**SAN JOAQUIN RIVER**  
RESTORATION PROGRAM

# **Seepage and Conveyance Technical Feedback Group Meeting**

**February 8, 2013**

# **SMP PEER REVIEW PANEL FINDINGS**

Table 3: Predicted Groundwater Levels for Key Wells

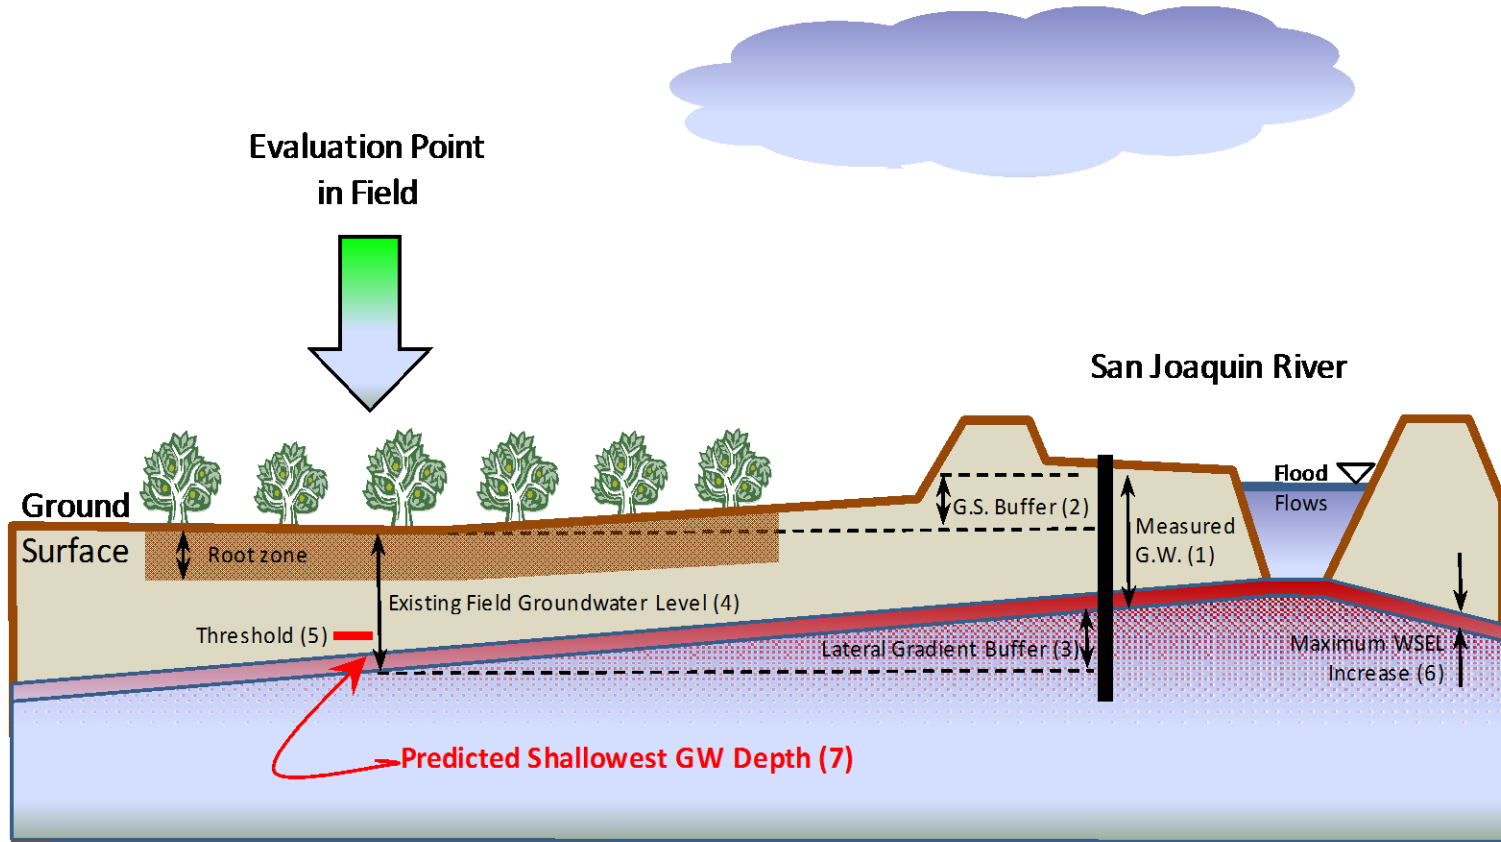
# Suggested changes to Table 3

## Suggested changes to the Rating Curves

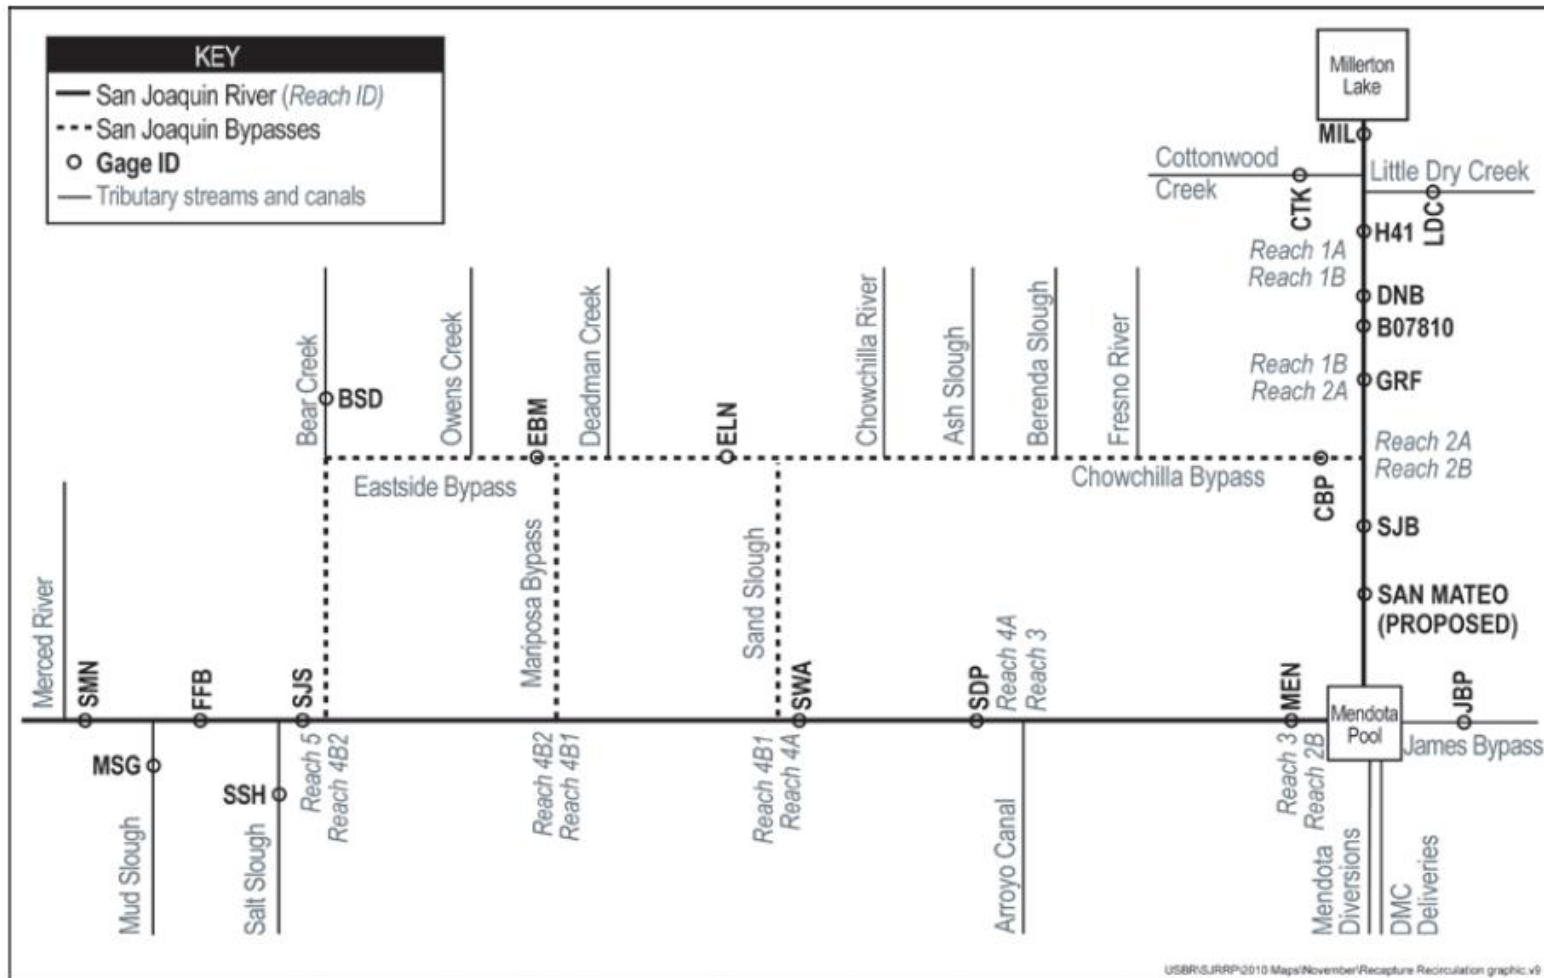
- The Flow Bench Evaluation Reports could be expanded and made more informative. The PRP found it difficult to interpret all of the information in the reports.
- The visual representation of what is happening during the drainage flow condition from a field is missing from the SMP and Flow Bench Evaluation reports. It is recommended that a new schematic be used to describe the drainage method.
- The PRP agrees with the method used to correct the field groundwater levels based on the flow bench evaluations. In the future, additional wells and operational knowledge will reduce the need for the field corrections.

Figure 12

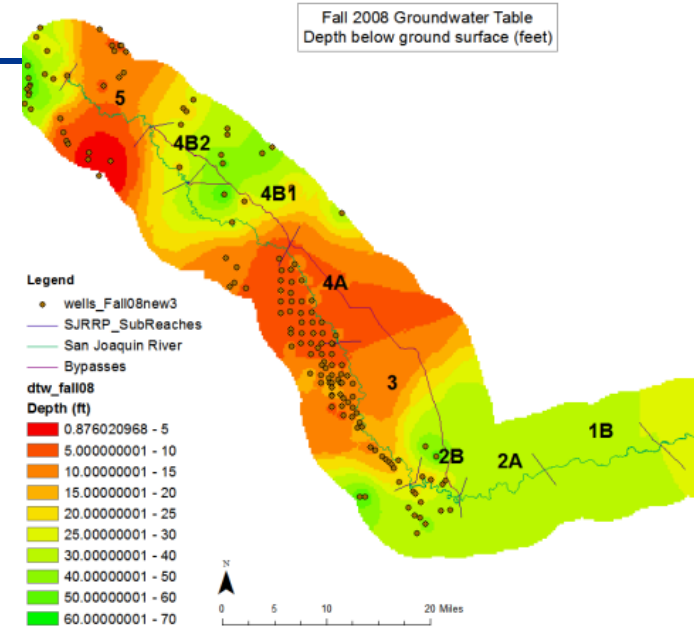
- Historical GW maps are sound.
- Recommend adding methods that refine and reduce potential errors caused by human, spatial density and interpolation techniques used to create maps.
- Adopt a guideline for minimum spatial density used for all maps.

Figure 12

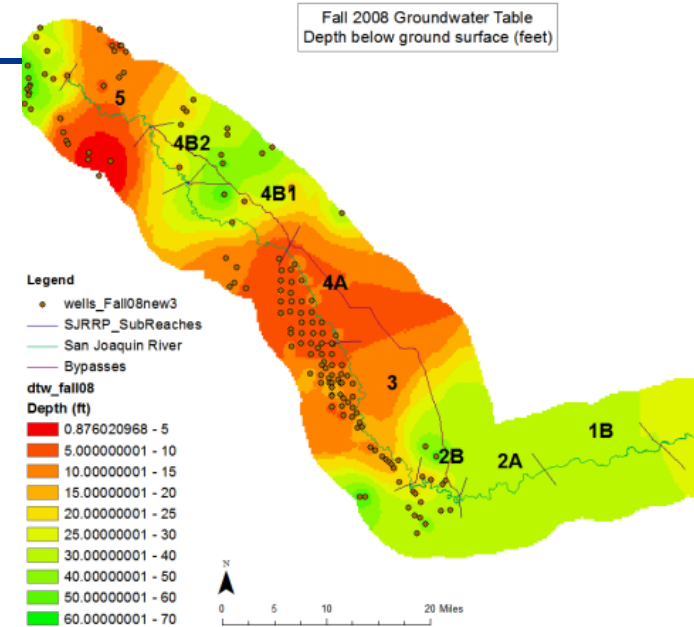
- Recommend Reclamation consult historical published reports including Soil Survey, predevelopment maps, other observed seepage records.

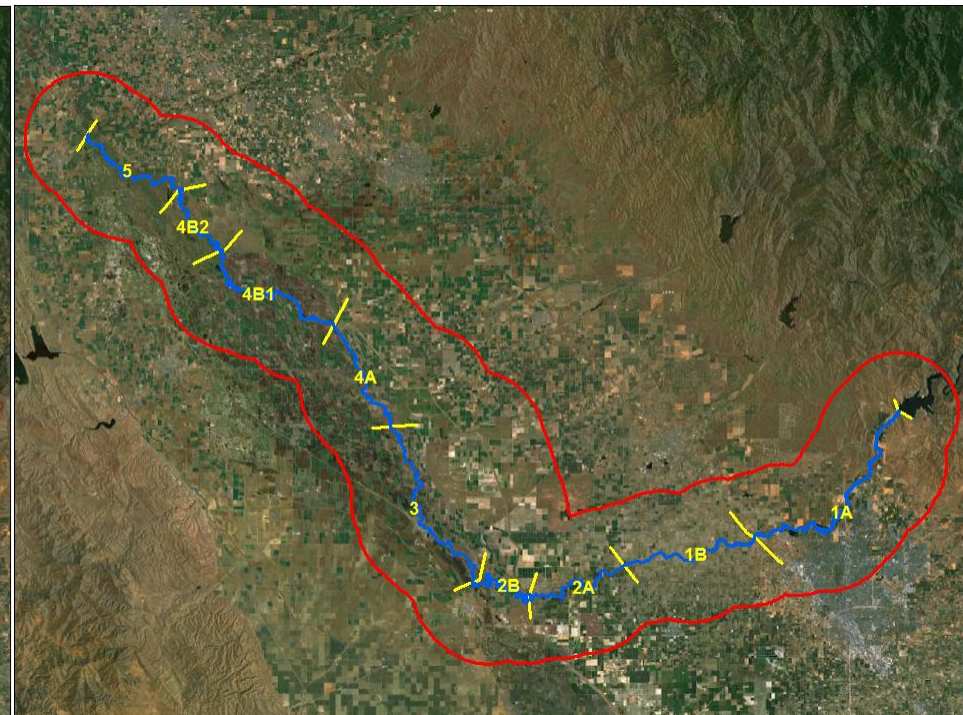
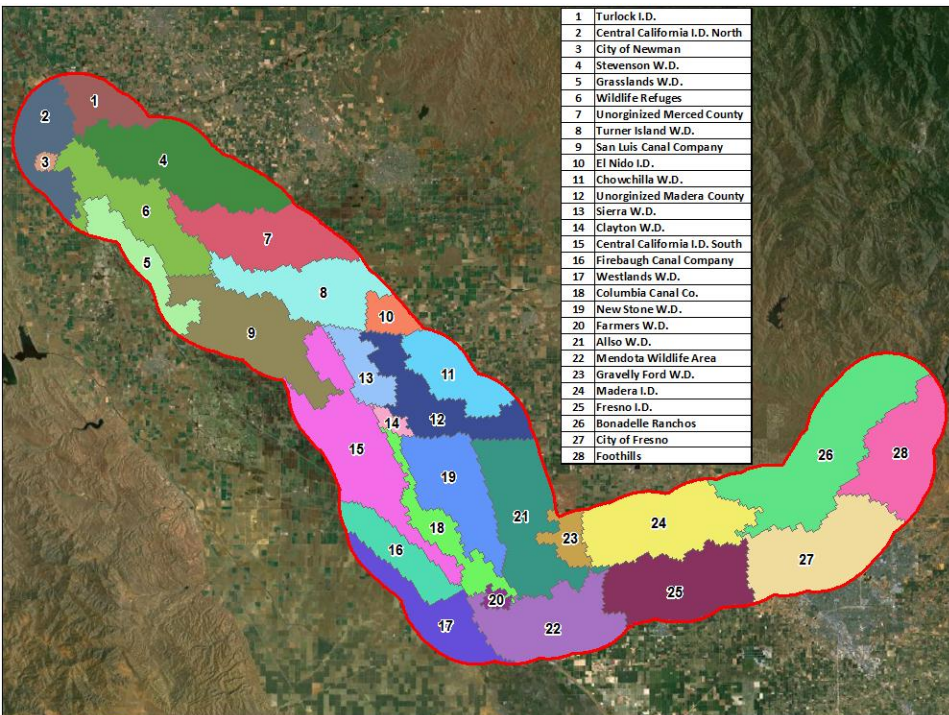
- Historical WT Maps are valuable but do not clearly address the magnitude and scope of the seepage problem.
- Need context and explanation

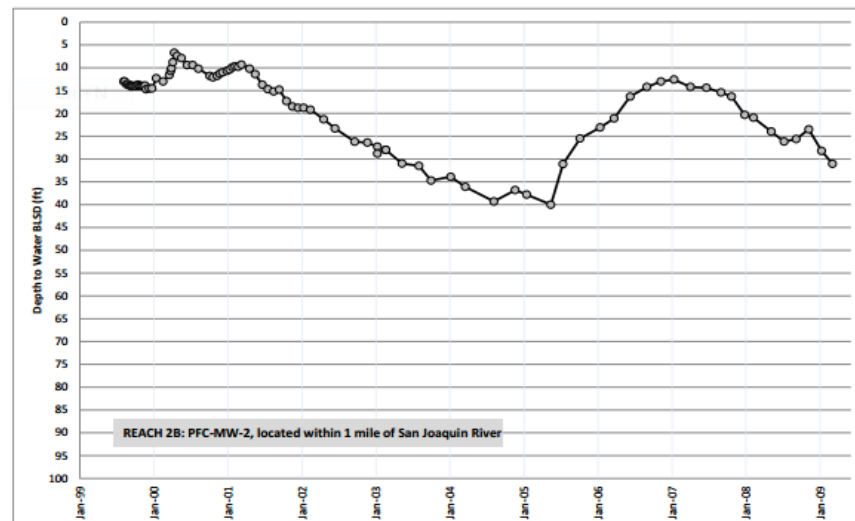
- Recommendation to develop a comprehensive diagram-model that describes the groundwater flow system and changes over time and space
- Recommend developing maps that delineate the magnitude of historic GW levels exceeding current thresholds

Figure H-7  
Thresholds developed using historical groundwater-level measurements in CCID Well 191

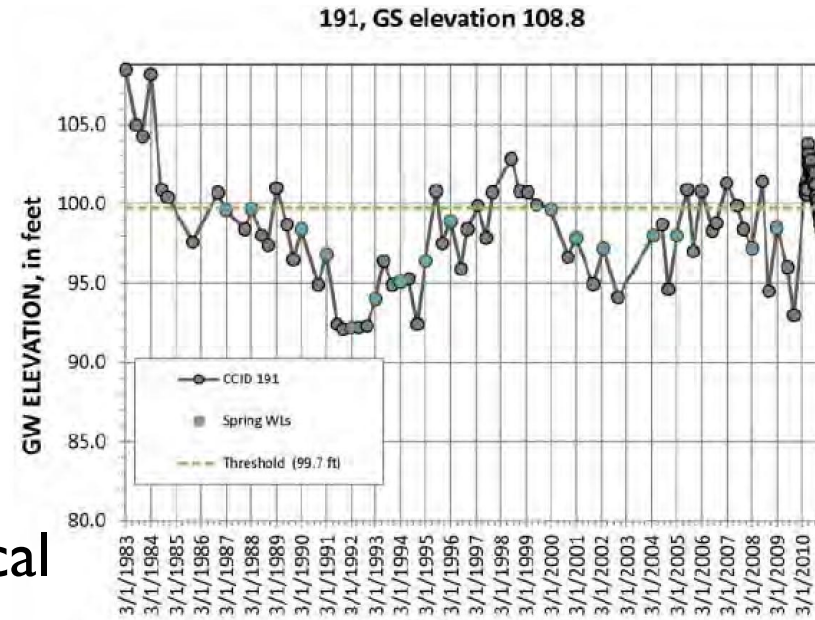
- Generally, historic levels are reasonable and help establish SMP thresholds.
- But depending on year type, historical levels could be overly conservative and potentially limit releases.
- Establishing year-type indexing will help evaluate what is or is not conservative
